From: Michael Eastham <Michael.Eastham@arun.gov.uk>
Sent: 17 December 2020 17:01
To: Planning.Responses <Planning.Responses@arun.gov.uk>
Subject: FW: A/109/20/RES - Re-consultation

Please upload onto Ocella the email below and the attachment from **Angmering Parish Council** objecting to reserved matters application **A/109/20/RES** relating to Land South of Water Lane, Angmering.

Please see the attached objection to A/109/20/RES, due to be heard at Development Control Committee on 6 January 2021.

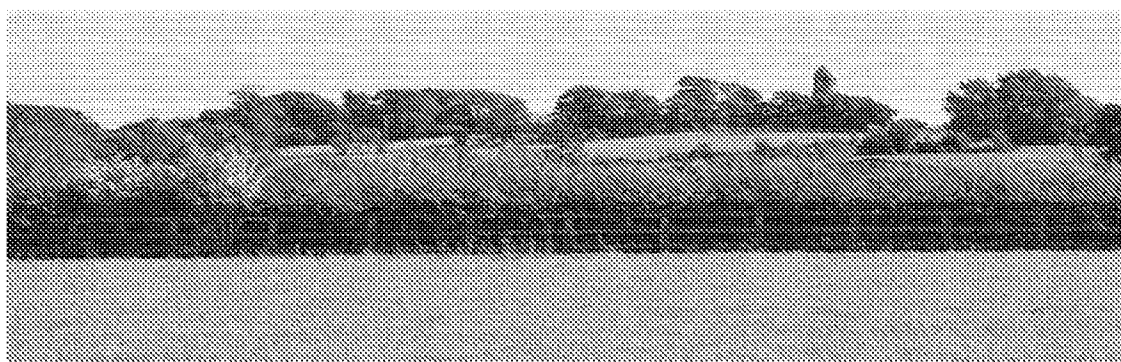
The applicant has said they are proposing to relocate the existing water main into the highway and that they *will liaise as appropriate with Southern Water*". As far as we can

see, the latest site layout plans do not show any proposed rerouting of the existing water main.

Their latest email dated 15 December says *“Southern Water would not recommend approval of layout, until the applicant demonstrates that the standoff distance from the public water distribution main is to be maintained. The comments in our response dated 29/09/2020 remain unchanged and valid.”*
